PROJECT **123A90 - HOLLANDSE KUST NOORD WIND PARK**
BLPH Project

MECHANICAL COMPLETION DOSSIER (ONSHORE)

Junction Box 950-JE-02102 and Multi-core cable (FGS System)

PUNCH ITEM ENTRY / CLEARANCE FORM

C30002535

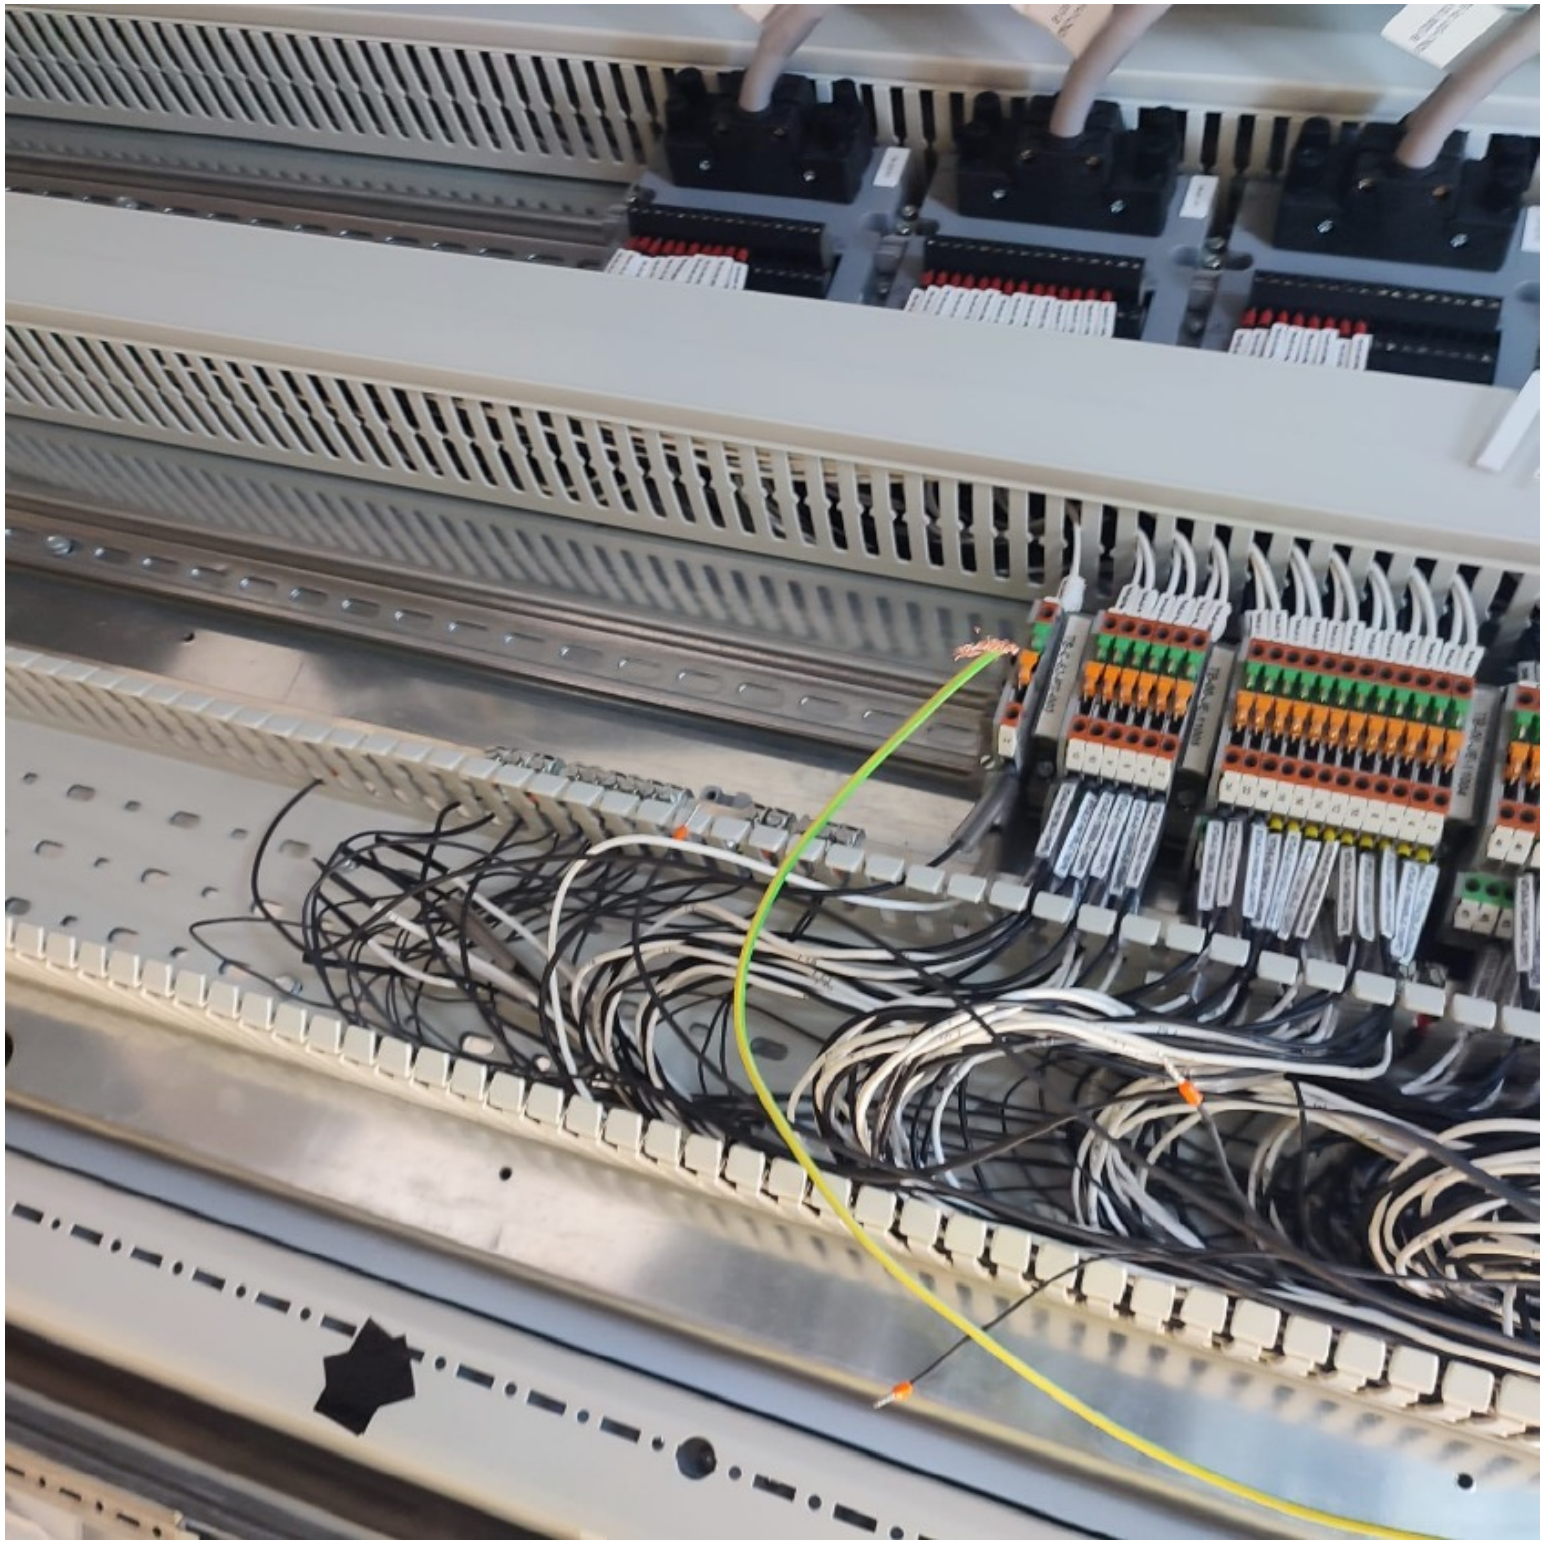
Partial shield as not connected on the terminal board. side the (B400-FGS-003). See attached photo.

DONE

C30002513

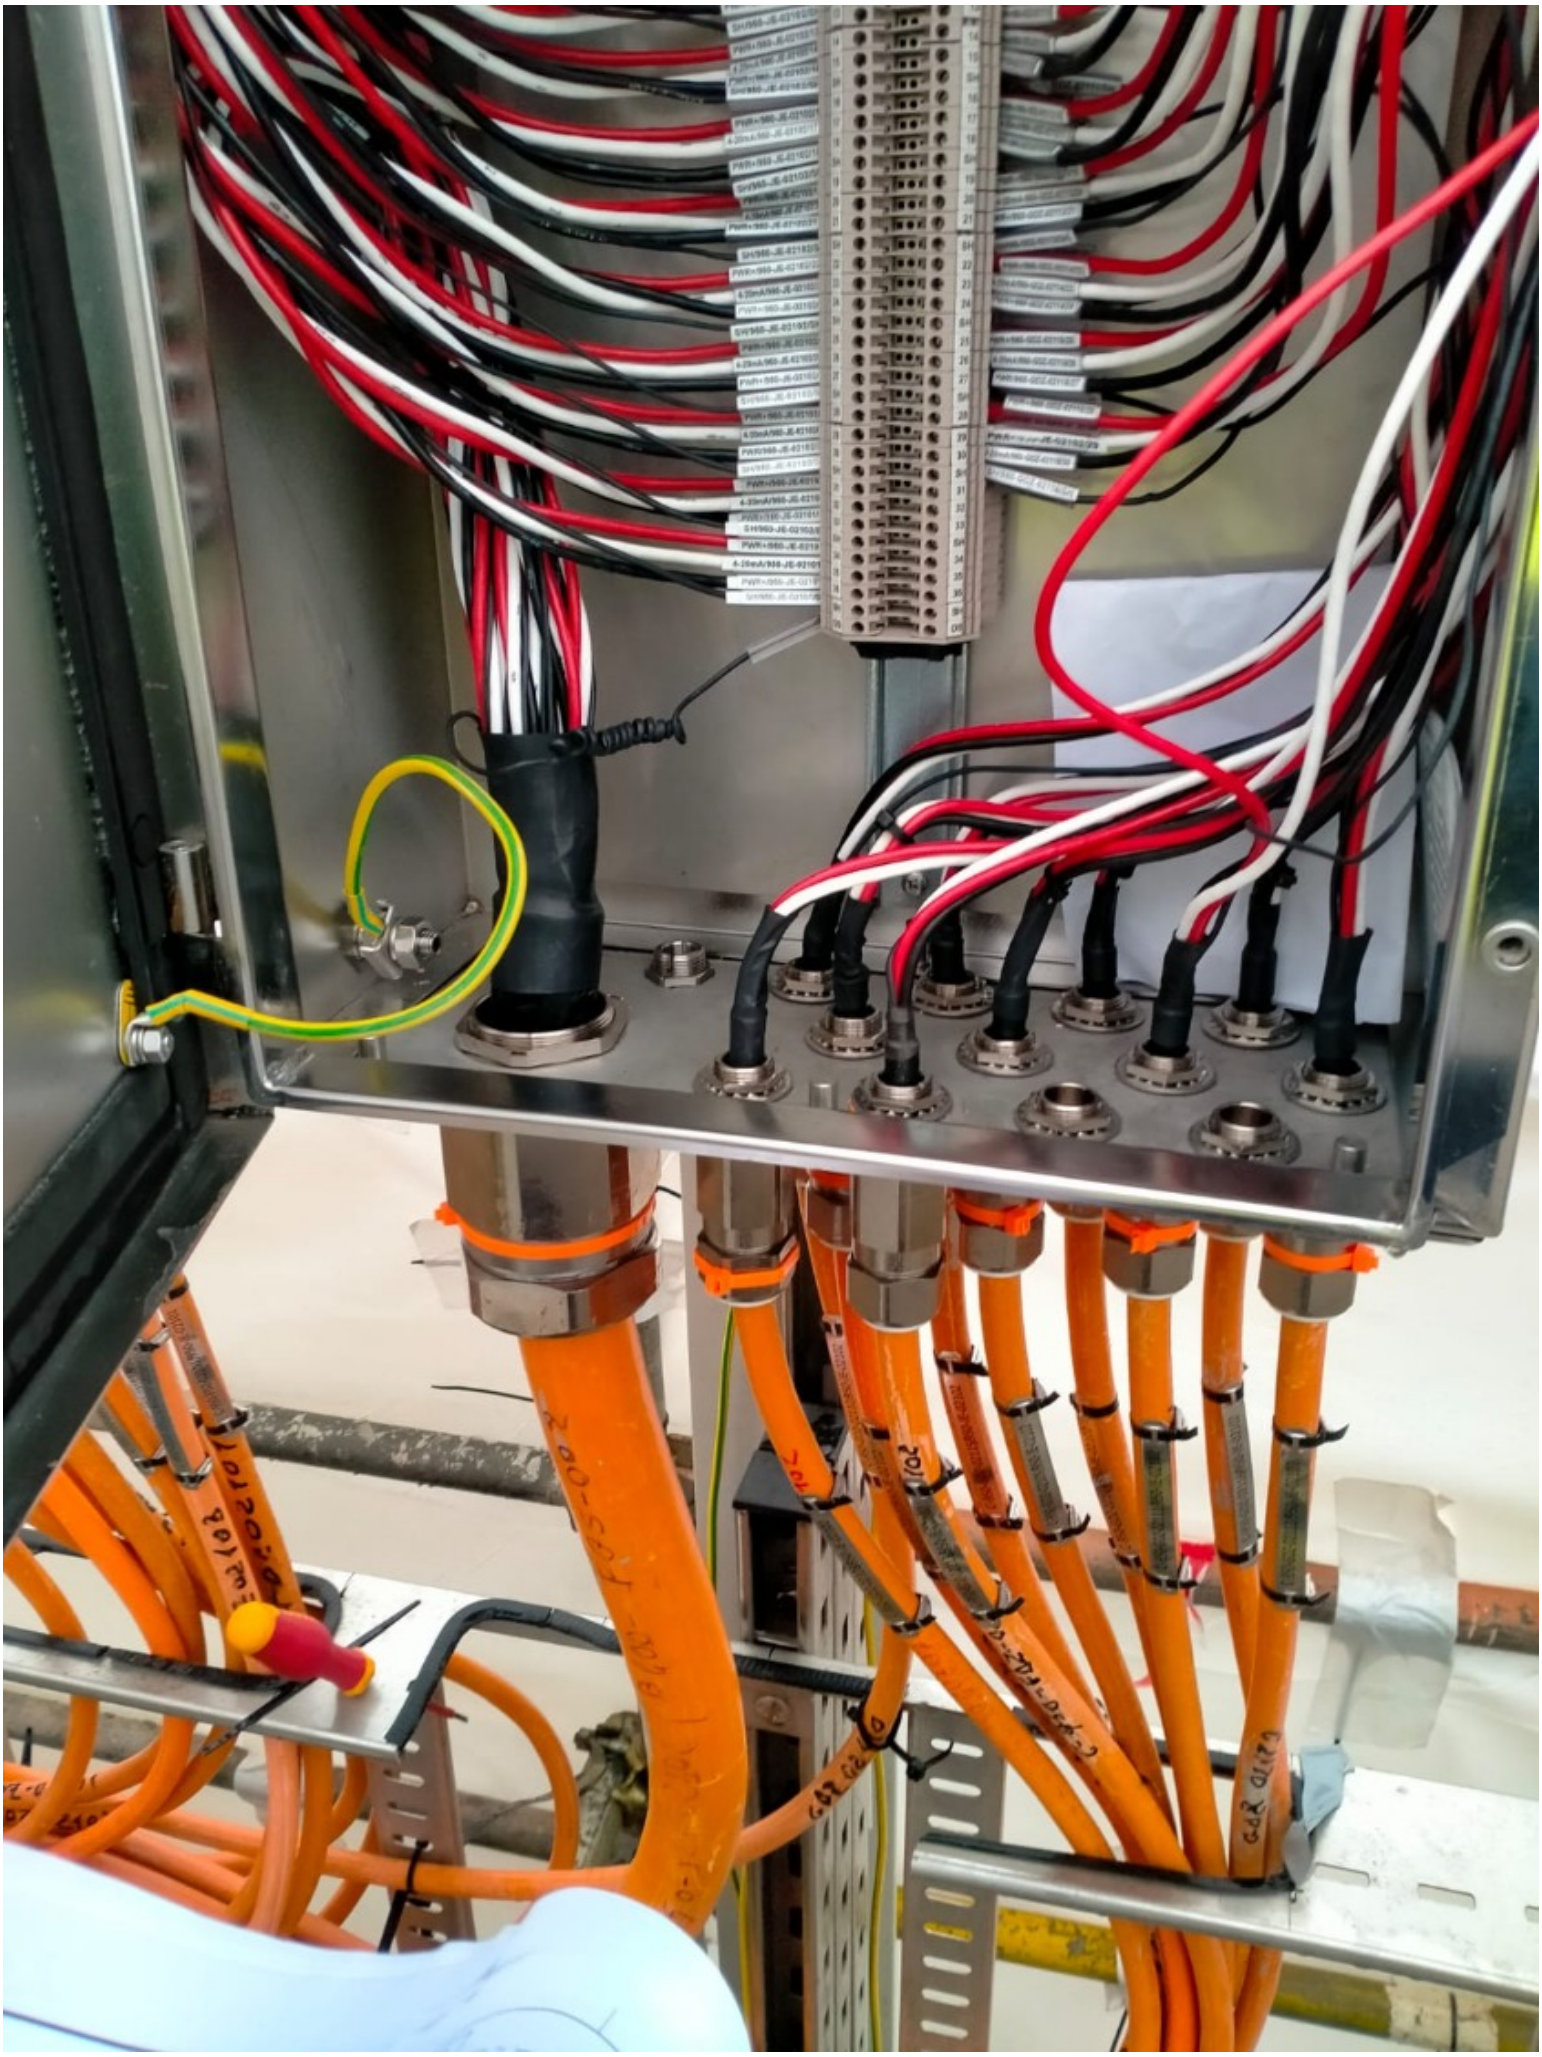
Missing jumper inside the JB.

Done

C30002515

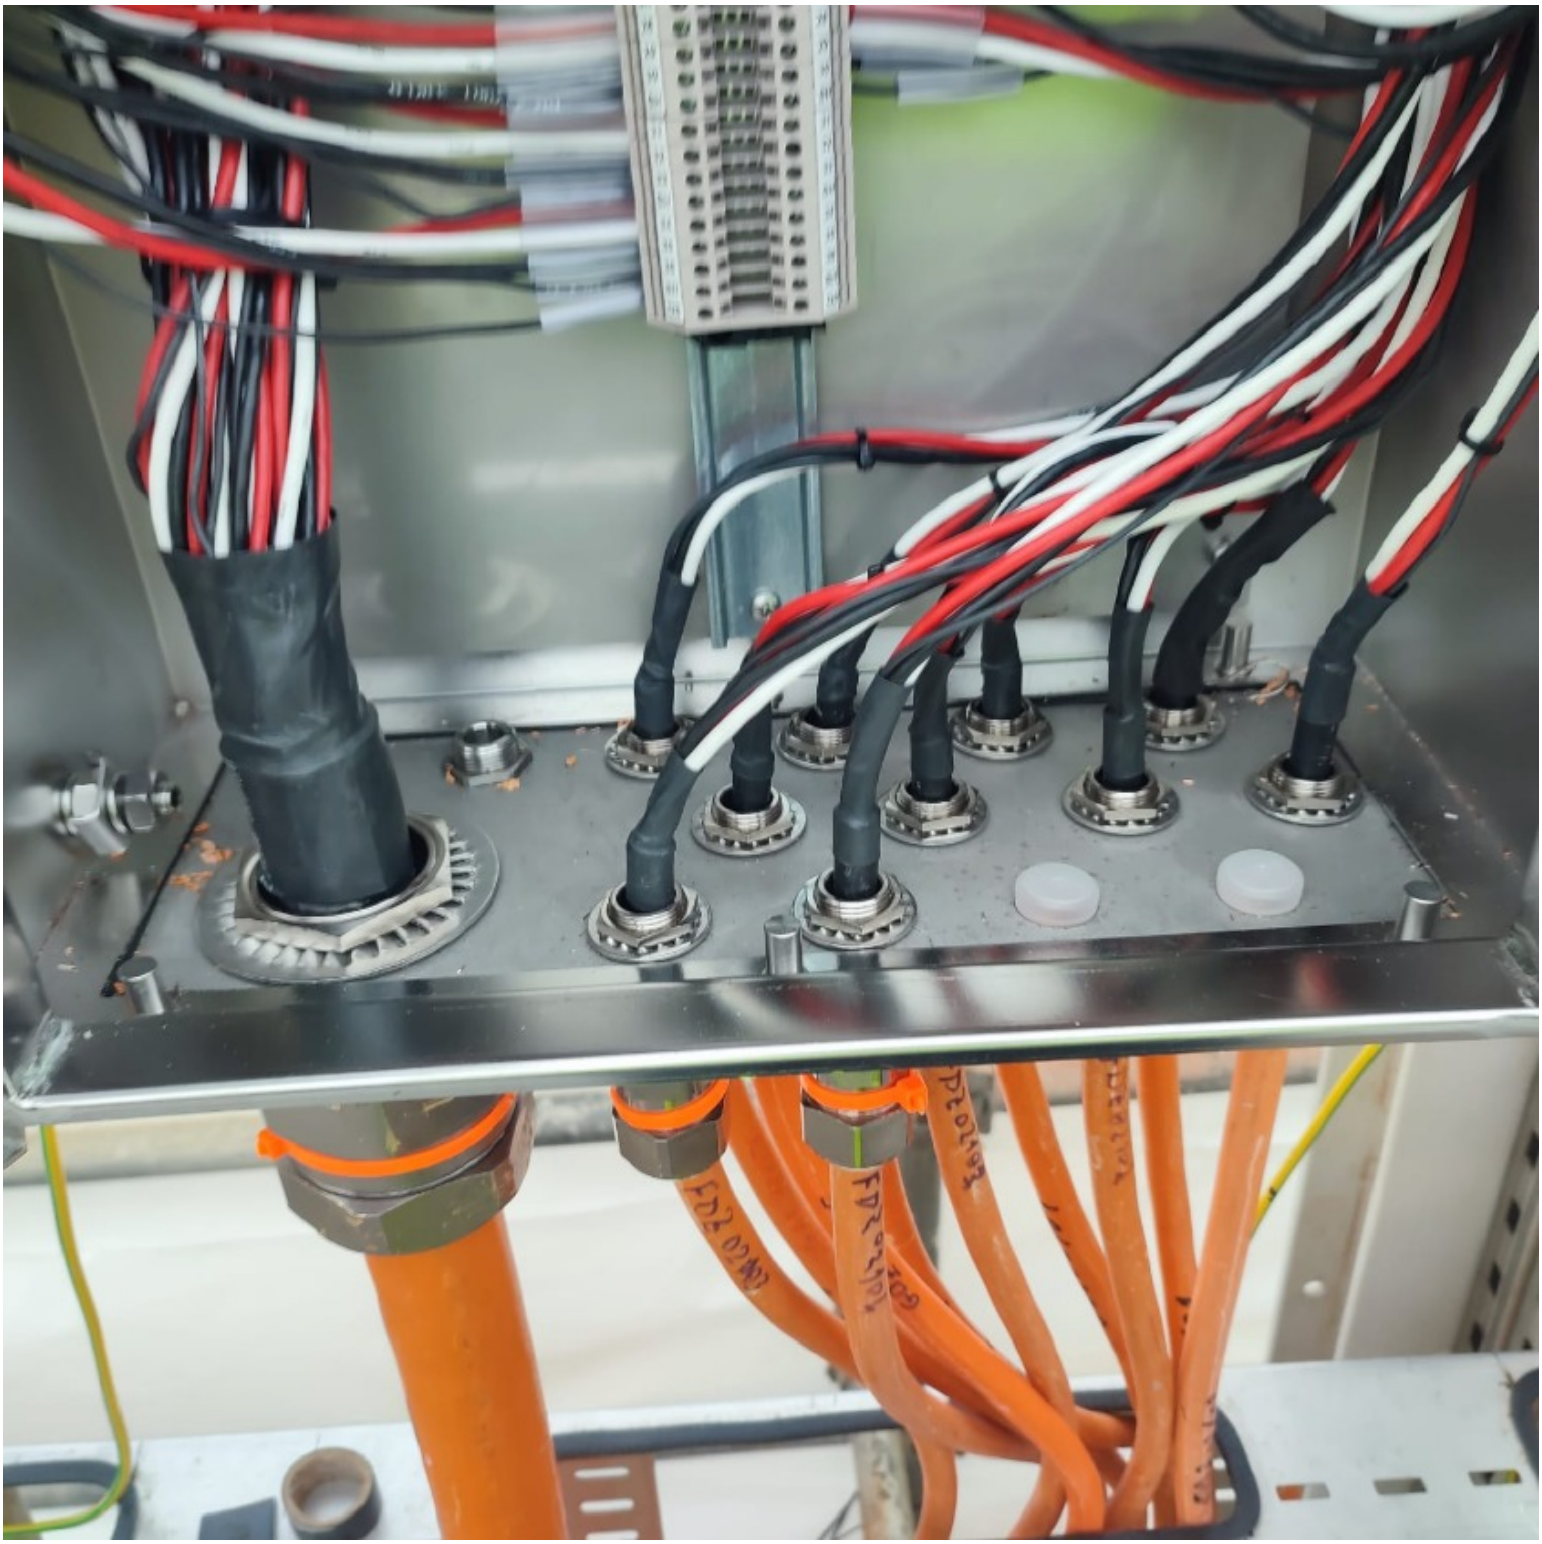
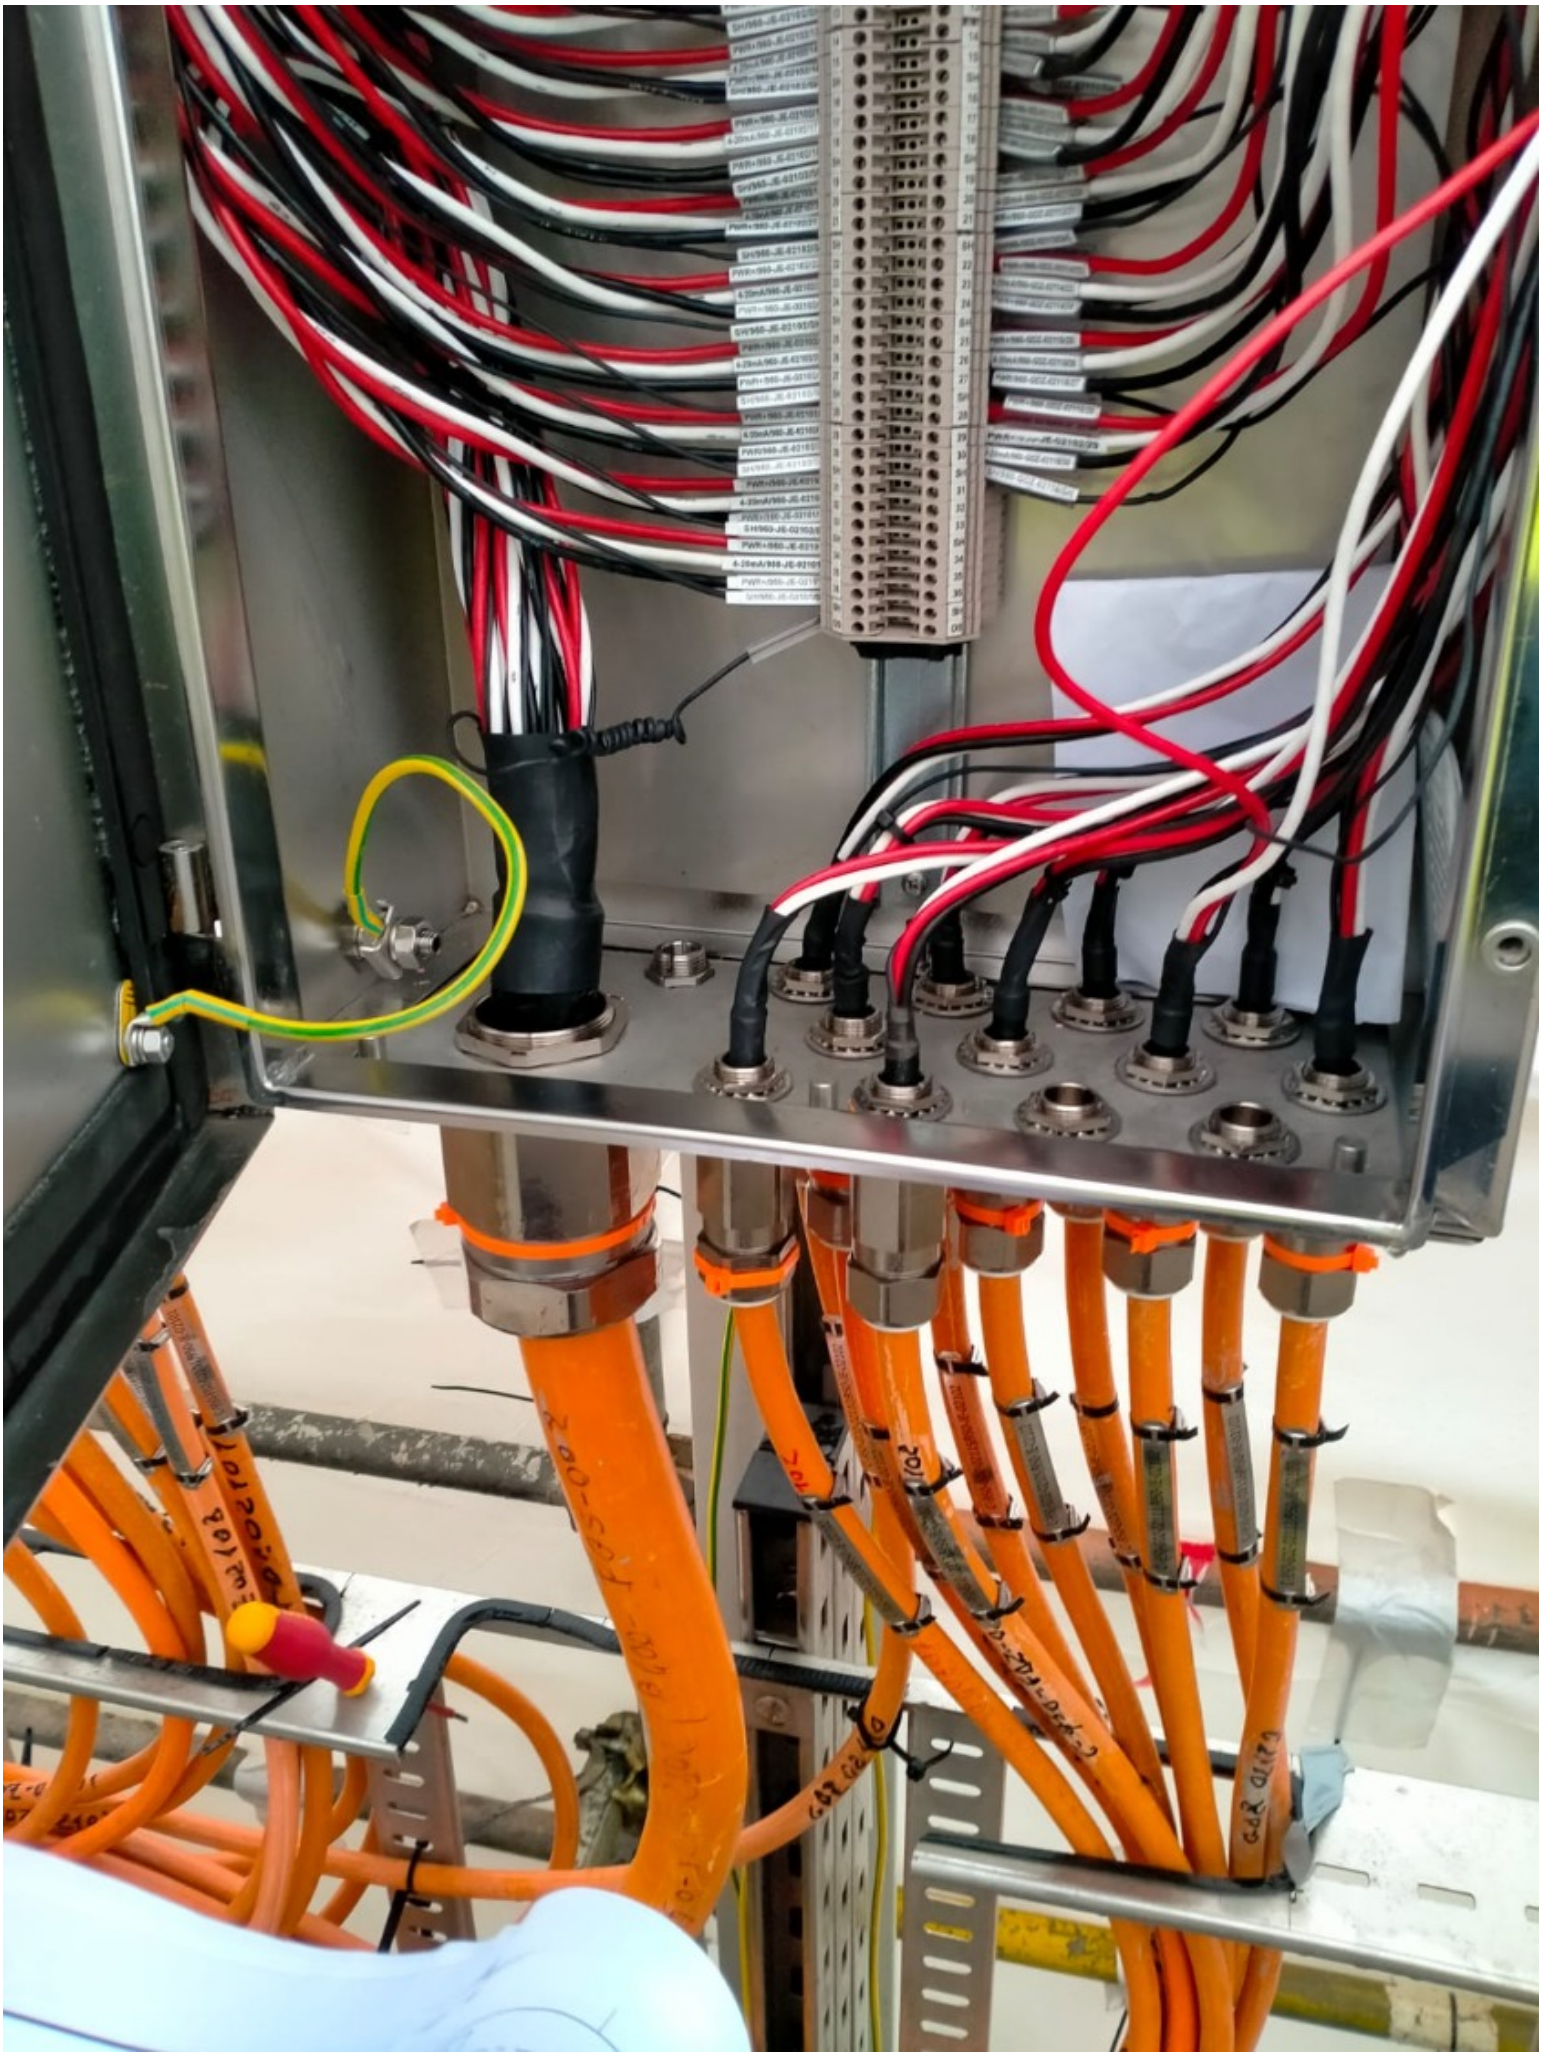
Cleaning is required inside the panels. See attached photo.

Done
